Access Compliance Report

Public Rights-of-Way

(Curb Ramps)

Intersection ID: 12611	Main Street: S_CHURCH_ST	Cross Street: W_STONEWALL_ST	Location: E
ADA ID: EC08091DB7E4	Ramp Type: Perp	Initial Pass/Fail: Pass	Overall Compliance: No
Severity Score: 0			
Codes/Mitigation Info/Possible Solution		Field Measurements/Component Compliance

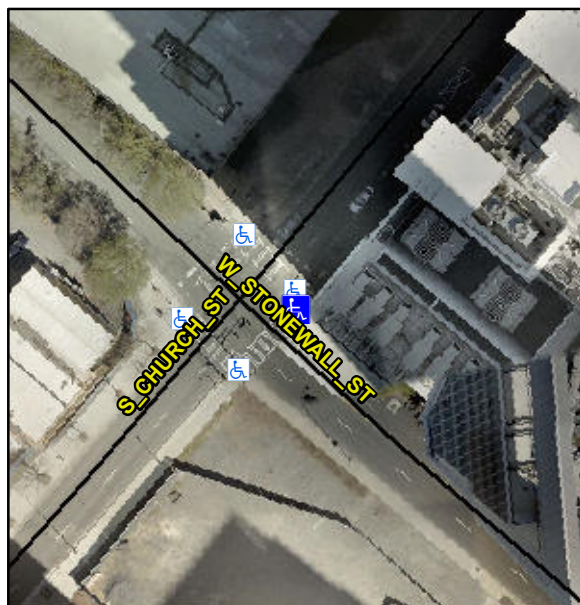
Not Found, R304.2.1, R304.2.2-Perp, R304.3.2-Para

Compliance	Description	Data	Compliance	Description	Data
N/A	Ramp Length (in)	32.0	Yes	Ramp Slope (%)	6.0
Yes	Ramp Width (in)	59.0	Yes	Ramp XSlope (%)	1.6
N/A	Flare Type LT	Sloped	N/A	Flare Type RT	N/A
N/A	Flare Slope LT (%)	3.6	Yes	Flare Slope RT (%)	5.8
N/A	Flare Traversable LT?	Yes	N/A	Flare Traversable RT?	Yes
No	Landing Length (in)	44.0	Yes	DWS Provided?	Yes
Yes	Landing Width (in)	60.0	Yes	DWS Contrast?	Yes
No	Landing Slope (%)	3.2	Yes	DWS Length (in)	24.0
Yes	Landing X Slope (%)	0.0	Yes	DWS Full Width?	Yes
N/A	Landing Curb? (Y/N)	No	Yes	DWS Offset (in)	0.0
N/A	Shared Landing?	Yes			
Yes	Gutter Ponding?	No	Yes	Gutter Slope (%)	0.8
Yes	Gutter Lip Ht (in)	0.0	Yes	Gutter X Slope (%)	1.3
N/A	Painted X Walk1?	No	N/A	Painted X Walk2?	N/A
	X Walk 1 Direction	To SW		X Walk 2 Direction	N/A
N/A	X Walk 1 Width (in)	N/A	N/A	X Walk 2 Width (in)	N/A
	X Walk 1 Slope (%)	1.2		X Walk 2 Slope (%)	N/A
	X Walk 1 X Slope (%)	1.5		X Walk 2 X Slope (%)	N/A

N/A	Ramp inside XWalk1?	N/A	N/A	Ramp inside XWalk2?	N/A
	Road Slope (%)	N/A	N/A	Clear Space?	Yes
	Road X Slope (%)	N/A	N/A	Clear Space to XWalk (in)	N/A
Yes	Any Obstructions?	No	Yes	Storm Grate/Utility Hazard?	No
	Obstruction Type			Storm Grate/Utility Type	
		N/A			N/A
			Yes	Surface Condition? (G/P)	Good

Possible Solutions:

Remove & Replace Entire Ramp.
